Proposal for amendments to UN Regulation No. 58 (Rear underrun protection)

The text reproduced below has been prepared by the expert from CLCCR to introduce amendments in document ECE/TRANS/WP.29/GRSG/2015/17. The modifications to the text in that document are marked in **bold** for new or ~~strikethrough~~ for deleted characters.

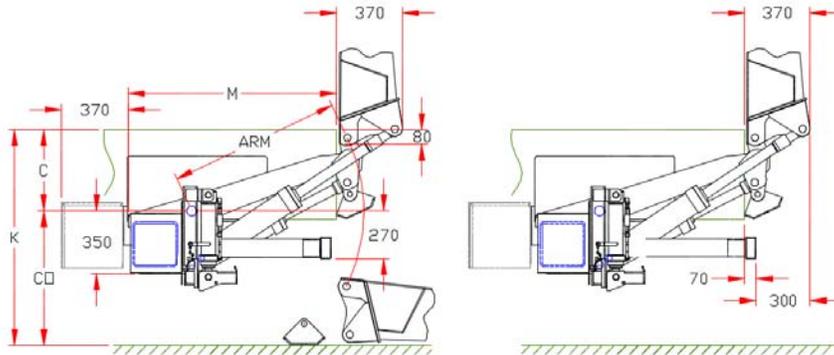
- with regard to the depth of the bumper under the vehicle, there are two issues that are important:
 - (i) The nominal value that the bumper can sit under the vehicle after deformation; and
 - (ii) The design parameters before / after deformation.

On (i) it is important that the nominal value after deformation remains 400 mm

On (ii) the text should keep the nominal value after deformation as design and verification parameter. If the maximum value is 400 mm after deformation, we believe that the text should leave it up to the manufacturer to design a weaker bumper that measures for instance 300 mm before deformation and deforms 100 mm while being tested; or if he designs a stronger bumper that measures for instance 350 mm before deformation, and only deforms 50 mm while being tested. In other words, if the legislator imposes a maximum after deformation, why also give us a minimum before deformation.

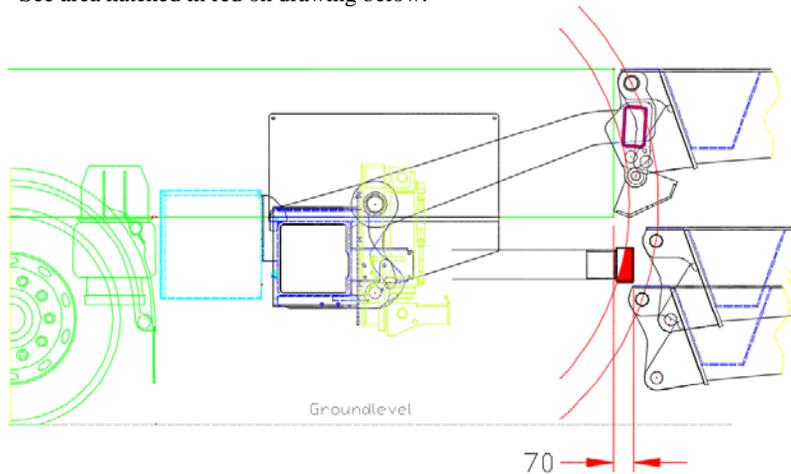
There are tail lifts commercially offered in Europe and across the world, that have platforms protruding behind the rear point of the vehicle body by more than 300 mm. In the case of this DH-LSU.90 7500-9000 kg it can be 370 mm for instance. With a rule of 300 mm before deformation, that would mean that the bumper bar sticks out 70 mm behind the vehicle body, which is shown in the drawing below.

- The next area of problems, which cannot be solved technically, is the reinforcement elements needed on all tail lifts, between the lift arms. When the bumper bar moves out behind the vehicle body, manufacturers will hit very rapidly impossible circumstances where that crucial torsion bar between the lift arms hits the bumper bar. See area hatched in red on drawing below.

- Other point again, is that the radius that the lift arm will describe in comparison to the bumper, is going to depend on the mounting height, which in itself is influenced by many other parameters such as available space etc. When the mounting situation is unfavorable, the front inboard edge of the platform will again hit the bumper bar. See also drawing above.
